THIS SITE IS LOCATED IN THE RENAISSANCE CENTER MASTER PLAN AREA AND IS LOCATED NEAR THE INTERSECTION OF INTERSTATE 25 AND MONTANO RD. IT IS BOUNDED ON THE SOUTH BY AN INDUSTRIAL PARK, ON THE WEST BY DESERT SURF CIRCLE, ON THE NORTH BY MONTANO ROAD AND ON THE EAST BY INTERSTATE 25 AND CONTAINS APPROXIMATELY 23.7 ACRES.

<b>ABRAHAM - BEACH PROPERTY</b> <b>INTERSTATE 25 AND MONTANO</b>	DRAWN BY BJF
	<b>BASIN MAP</b>	DATE 09/10/15
	<b>TIERRA WEST, LLC</b> 5571 MIDWAY PARK PLACE NE ALBUQUERQUE, NM 87109 (505) 858-3100 www.tierrawestllc.com	SHEET # <b>C2</b>
RONALD R. BOHANNAN P.E. #7868		JOB # 2015016

<b>ABRAHAM - BEACH PROPERTY</b> INTERSTATE 25 AND MONTANO <b>GRADING AND DRAINAGE PLAN</b>	DRAWN BY B.J.F. DATE 09/10/15 2015016_GRB
	TIERRA WEST, LLC 5571 MIDWAY PARK PLACE NE ALBUQUERQUE, NM 87109 (505) 858-3100 www.tierrawestllc.com	SHEET # <b>C1</b> JOB # 2015016

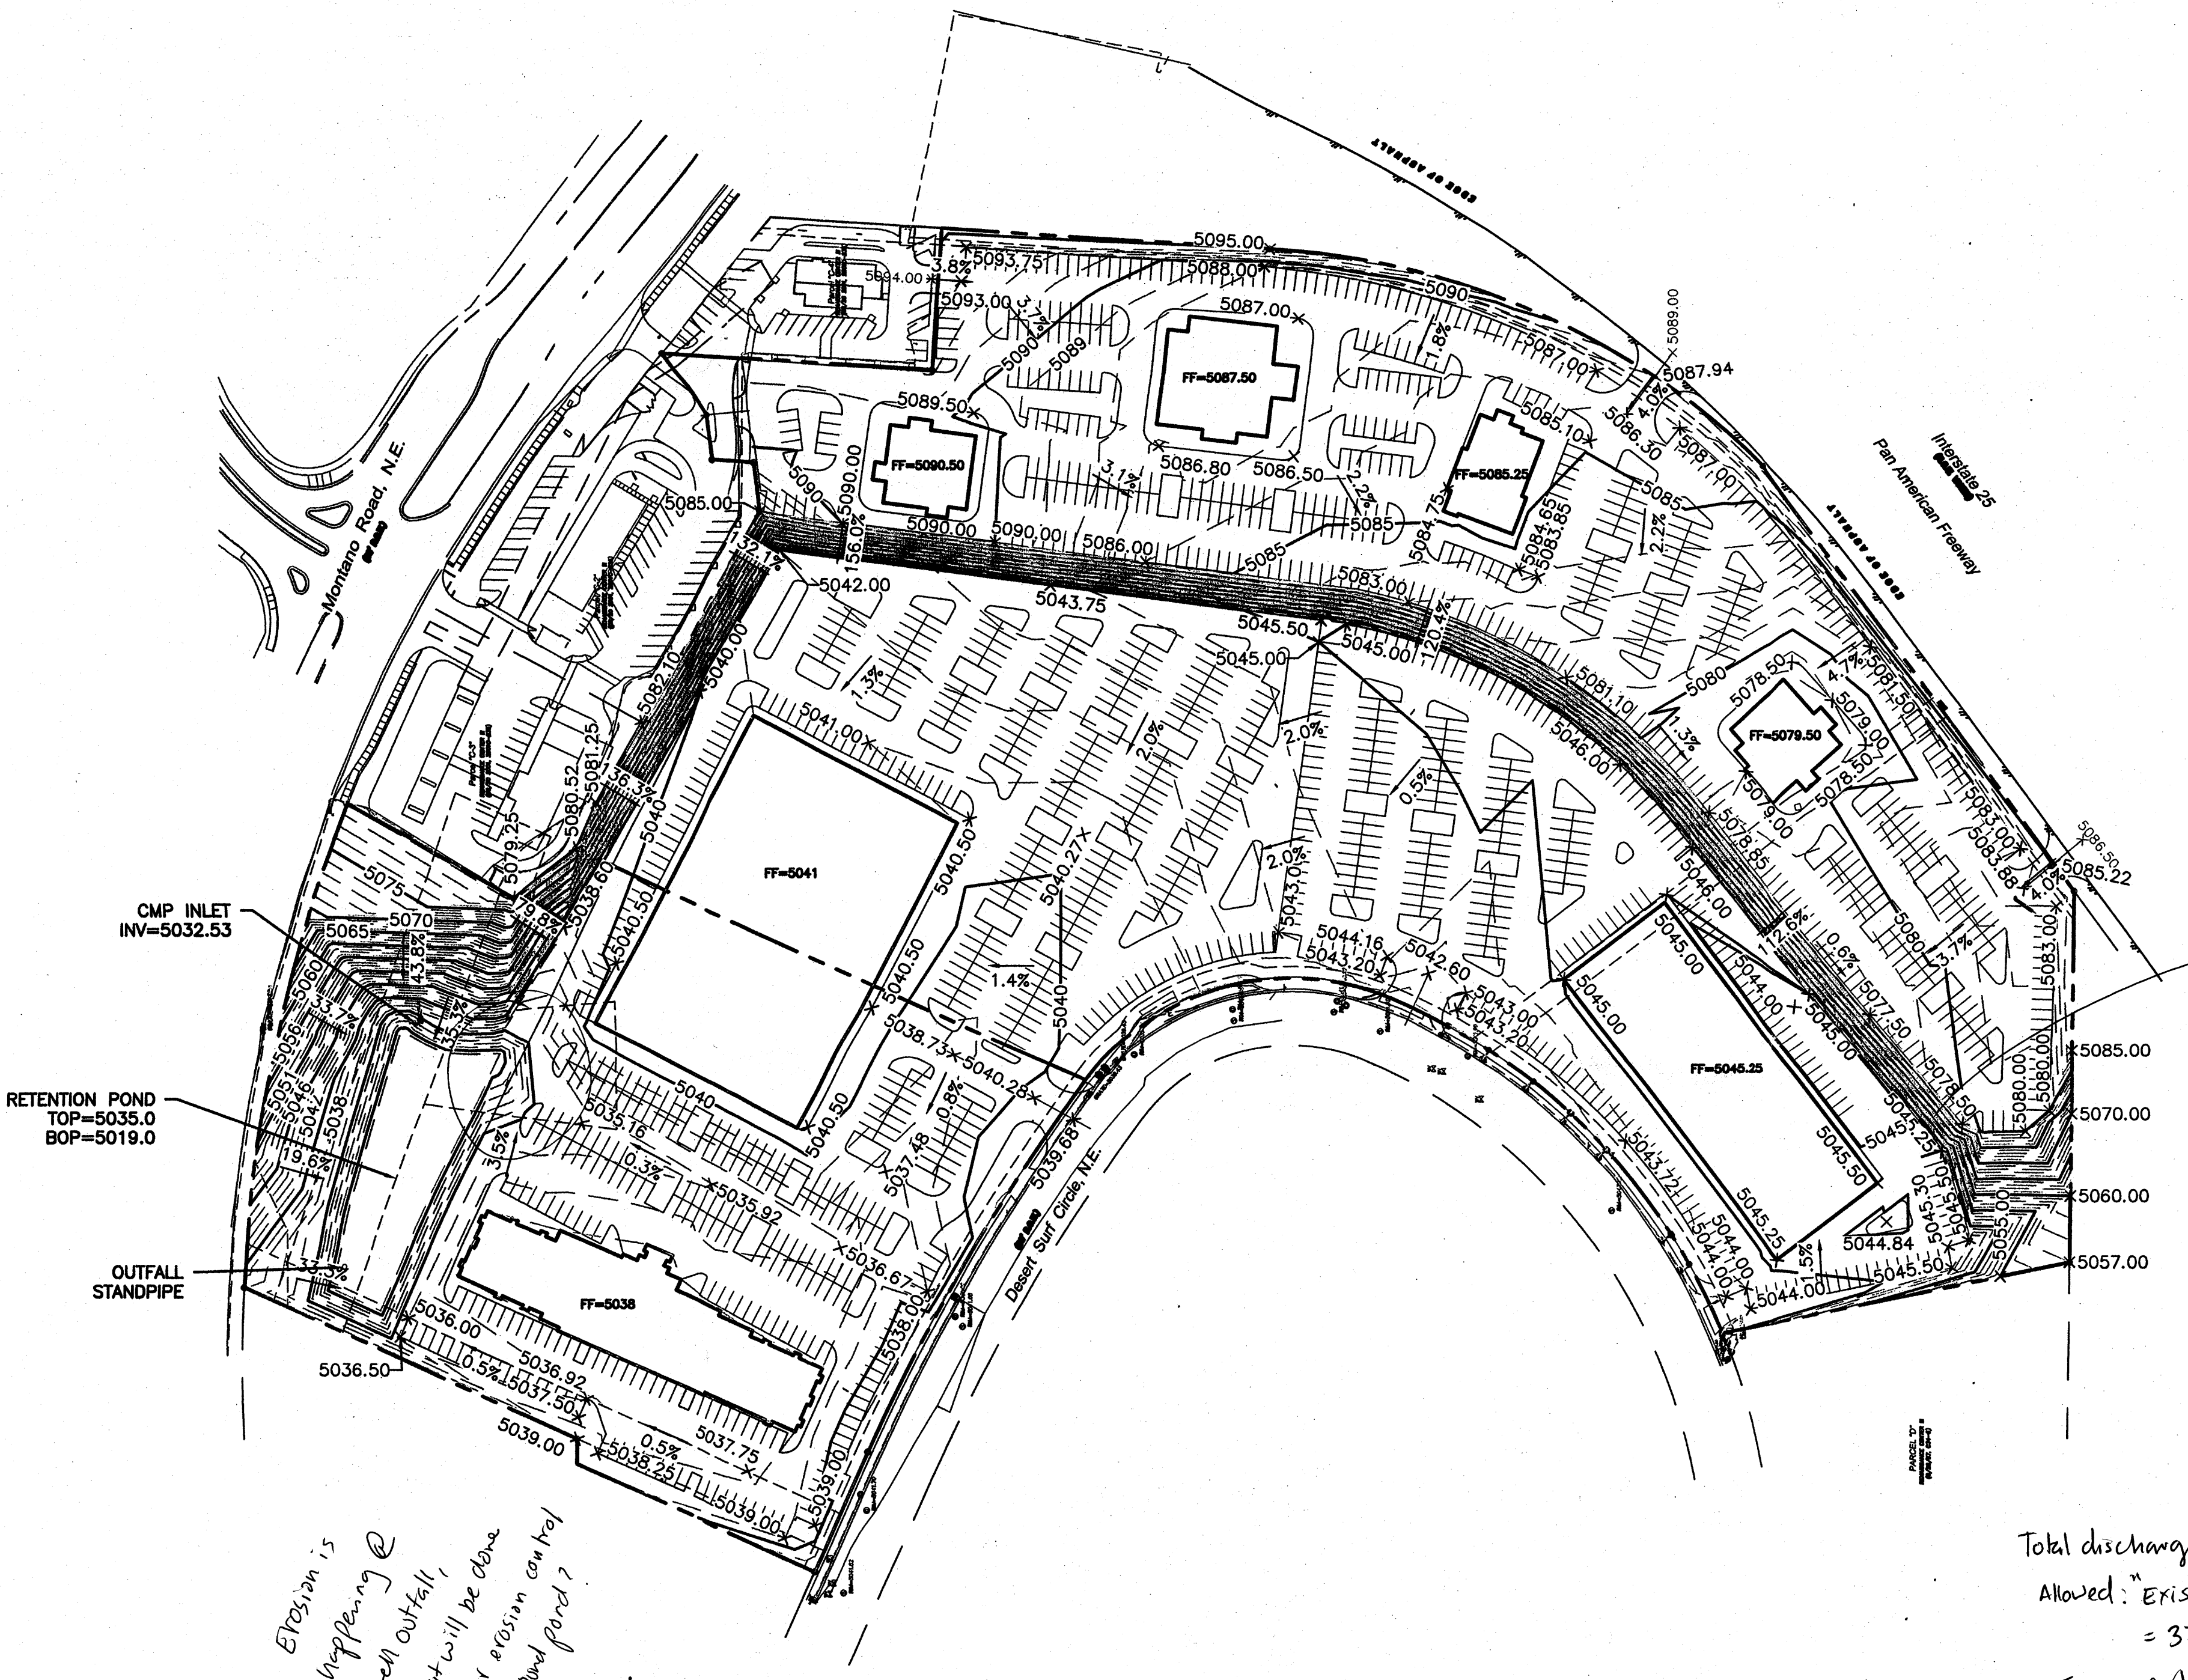
How are these very steep slopes protected?  
How do flows get from B1 and B5 to B2 and B6?

Erosion is happening @ Shell outfall, what will be done for erosion control around pond?

Total discharge from site:  
Allowed: "Existing" + 0.1 cfs/acre = 37.10 cfs  
From report, 2.66 + 28.17 + ~~1.99~~ = 30.83 cfs ✓

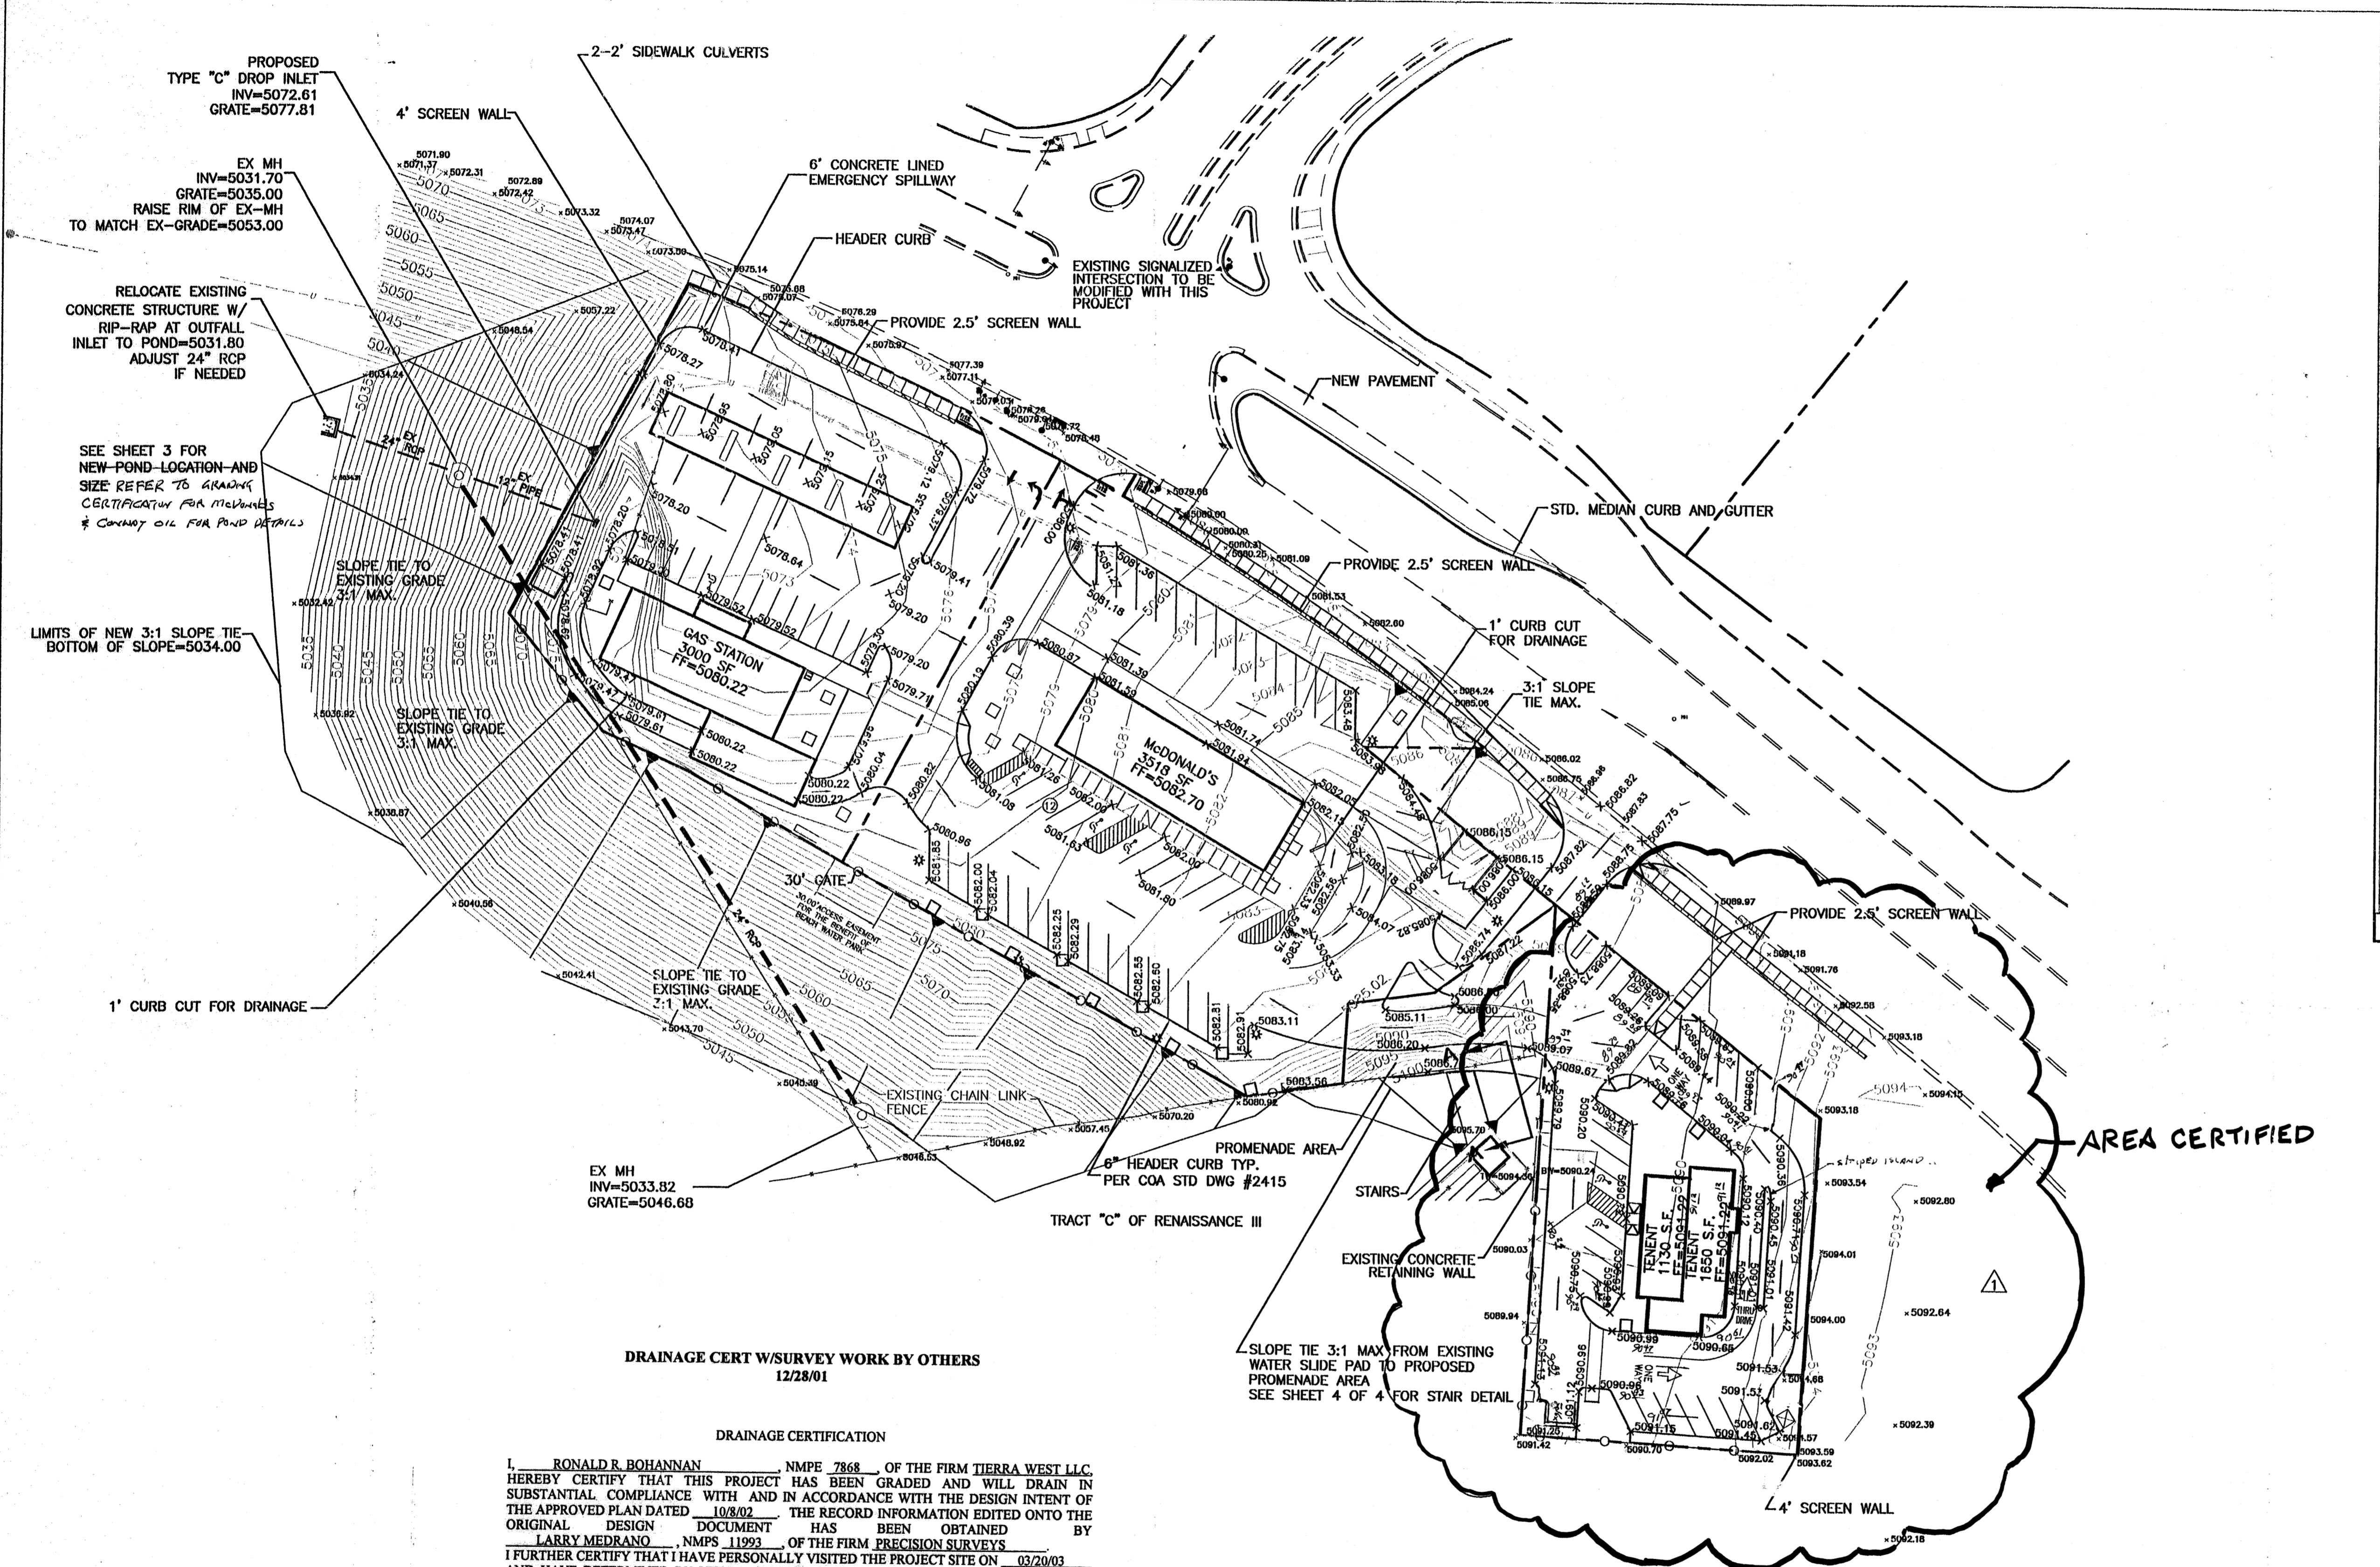
Show basins on G+D plan
